UNITED STATES PATENT AND TRADEMARK OFFICE

APPLICATION NO.	FILING DATE	FIRST NAMED INVENTOR	ATTORNEY DOCKET NO.	CONFIRMATION NO.
09/682,008	07/09/2001	David S. Leslie	11-SW-4904	1042

Office Action Summary

DETAILED ACTION

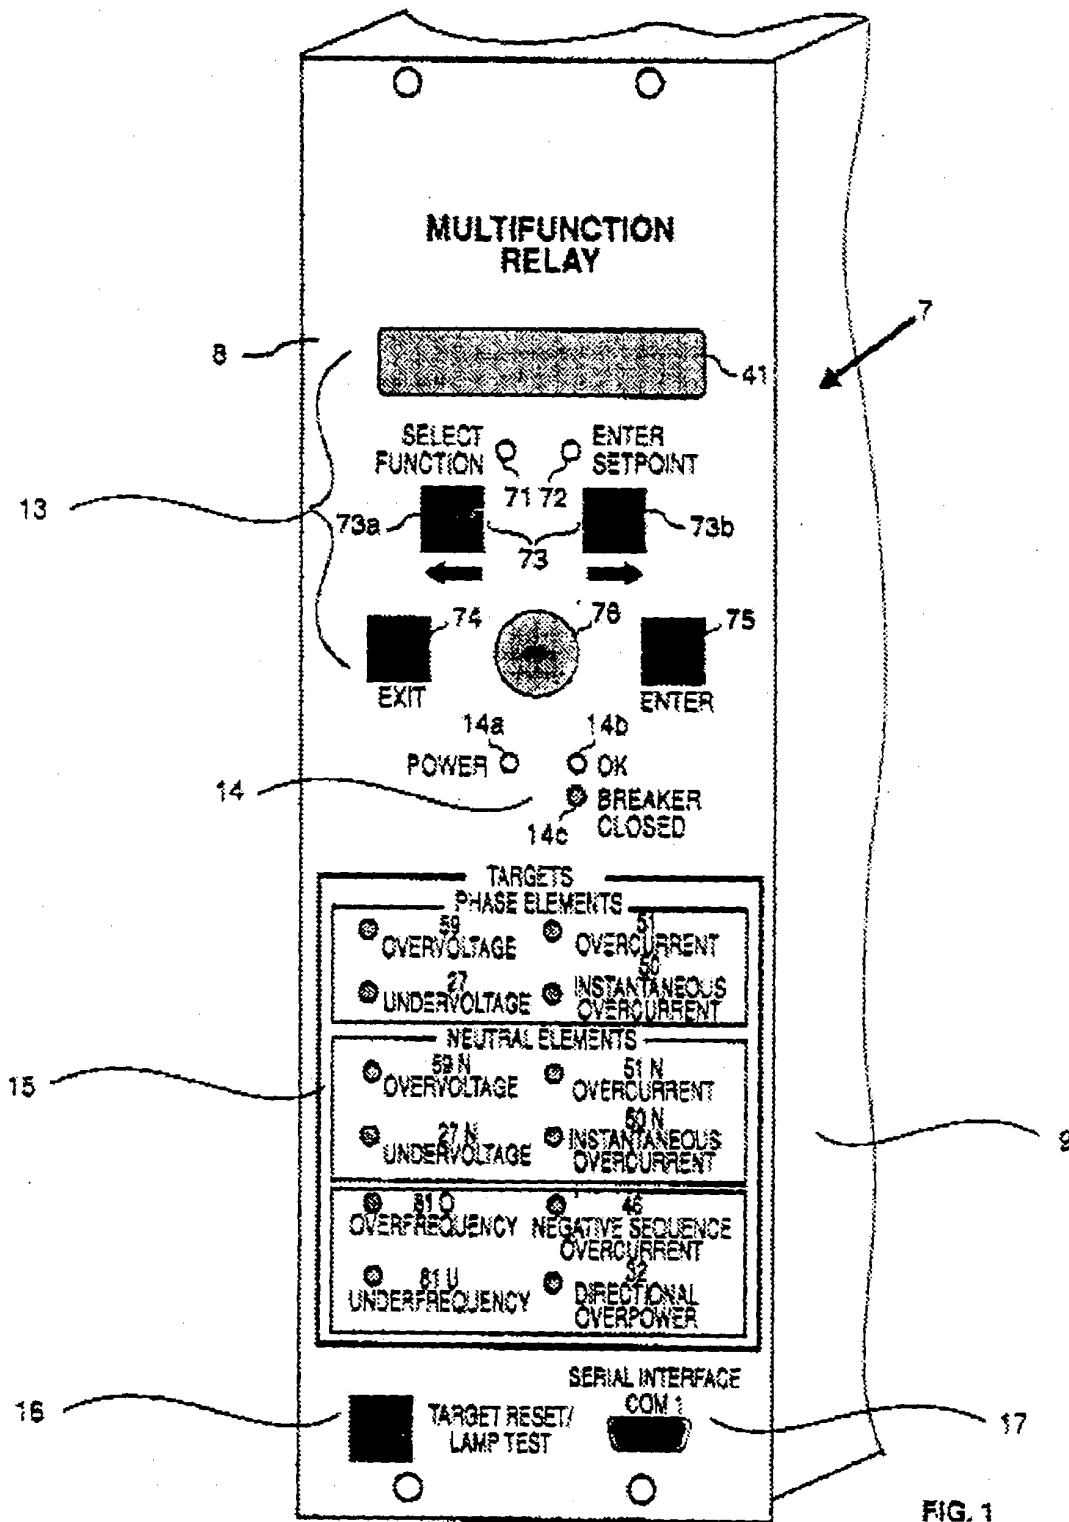
b) "displaying at least one of a relay contact status and the power values on a display" is seen in at least Fig. 1, see contact breaker status and various over- or under-voltage and current conditions, and also see the LCD element 41 of Fig. 5;

FIG. 5

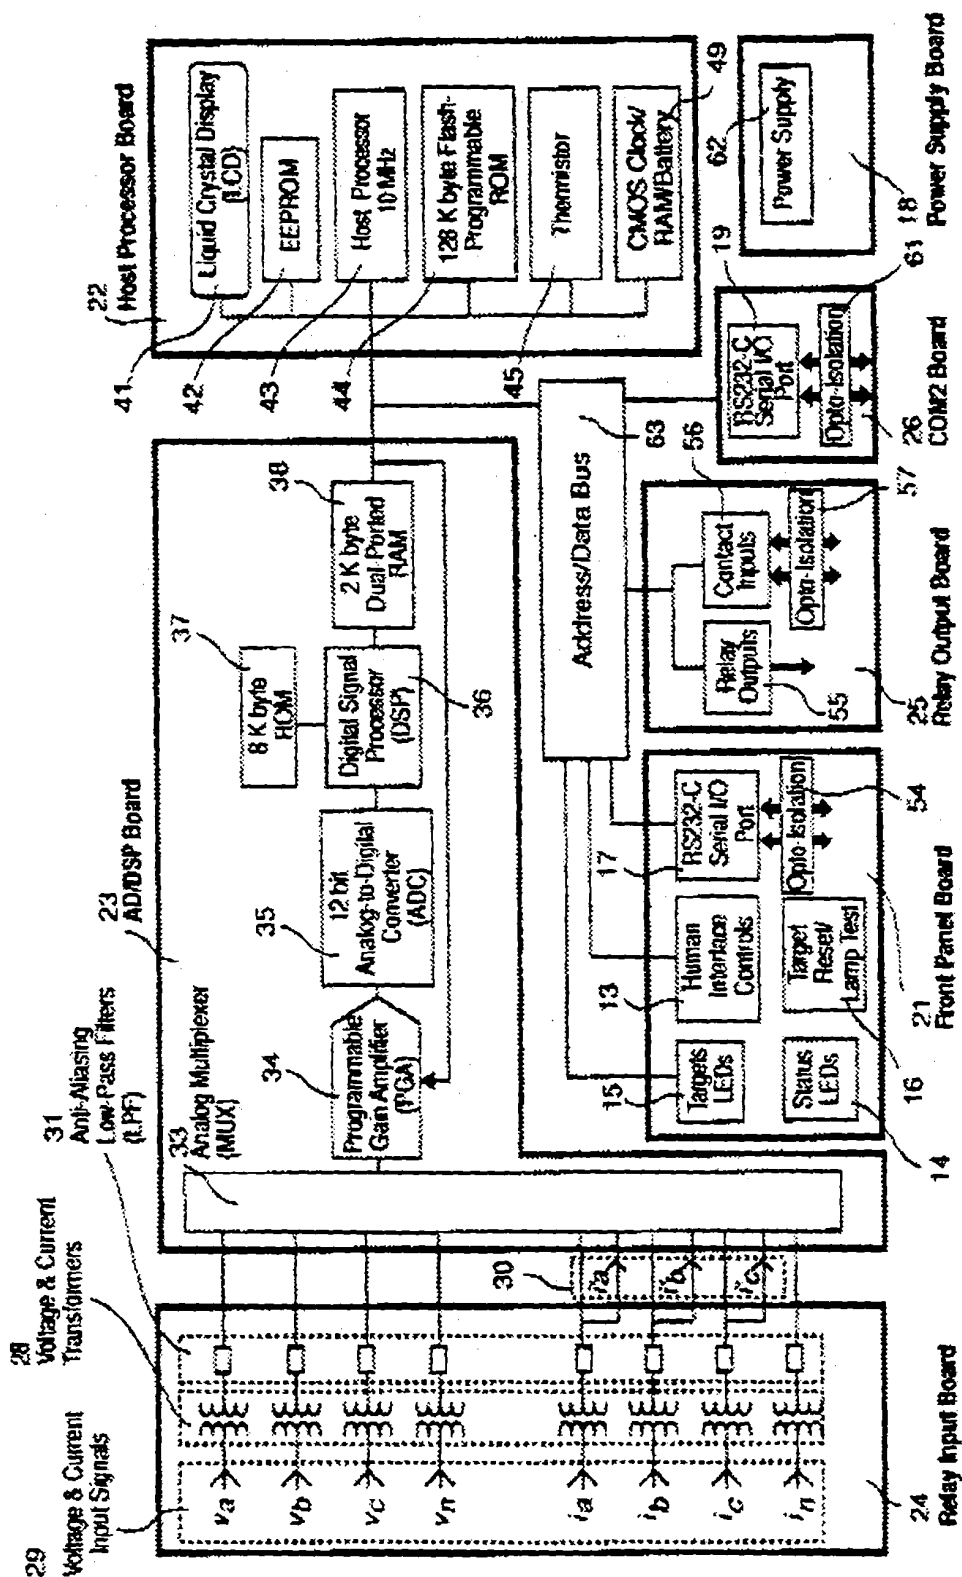
a) "measuring at least one of a voltage, a current and a phase angle" is seen in at least Fig. 5 with the numerous voltage and current input signals 29;

c) a "plurality of electrical relays" is the plurality of relays connected to the input and output boards in Fig. 5;

d) a "display" is LCD 41 of Fig. 5;

e) a "microprocessor" and "memory" are the combination processor 43 & DSP36 and RAM 38 of Fig. 5; and finally,

f) a "plurality of printed circuit boards..." is the plurality of boards seen in at least Fig. 5.

With respect to dependent claims 14-15 and 24, see at least the power supply and board 18,62 of Fig. 5 of Yalla et al.

16. Note that **Yalla et al.('011)** does disclose RS232-C I/O in at least Fig. 5.

FIG. 15

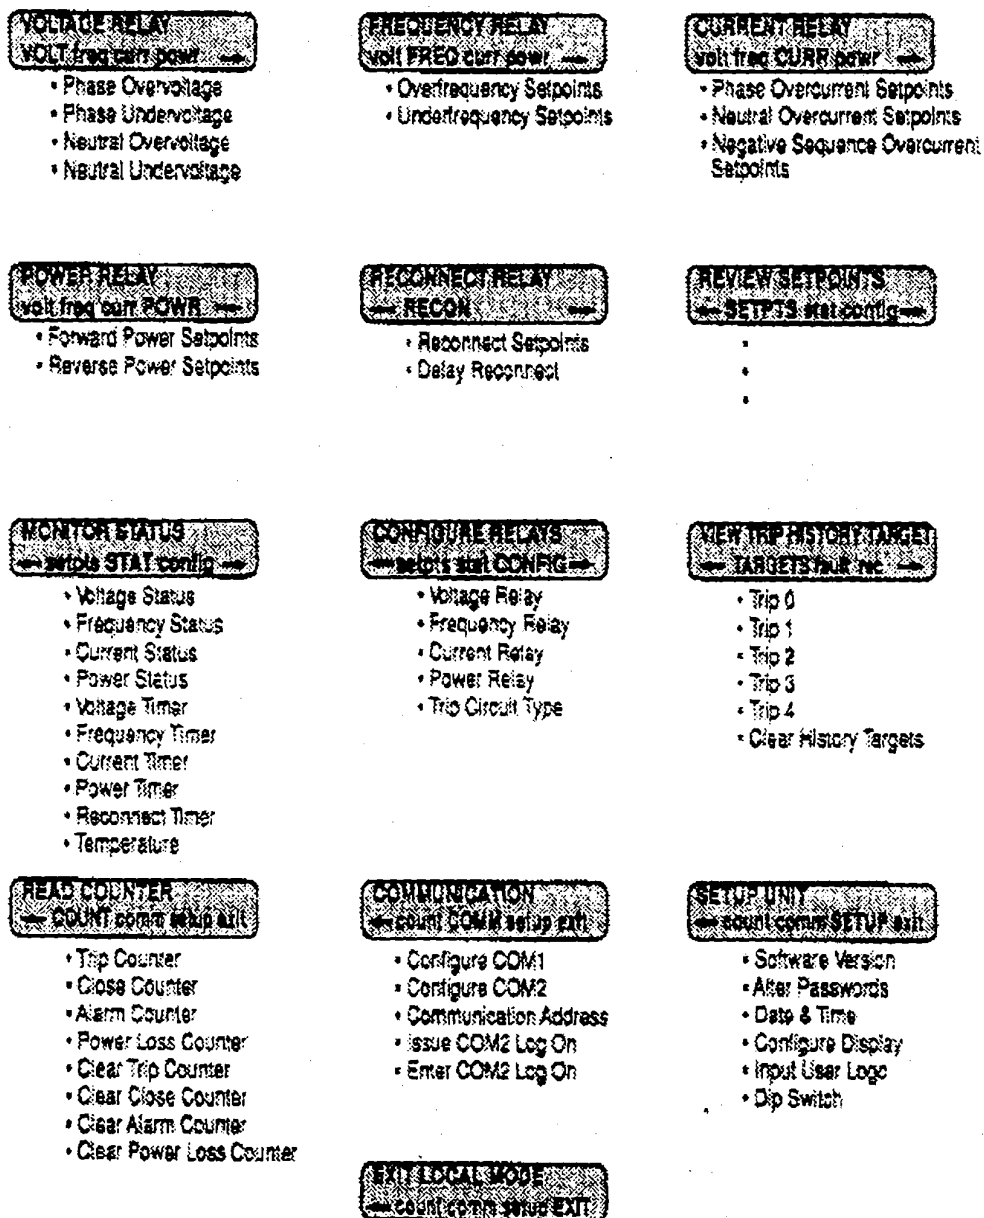
12. With respect to dependent claims 2, 16, 17, and 21, see at least the relay I/O boards of Fig. 5 and Fig. 15 of Yalla et al. which show numerous example relays and their related settings and related measurements.

With respect to dependent claims 7-8, and 18, see at least the Trip History of Fig. 15 or an example Trip time of occurrence of Fig. 16 of Yalla et al.

With respect to dependent claim 25, see at least the password of Fig. 15 of Yalla et al.
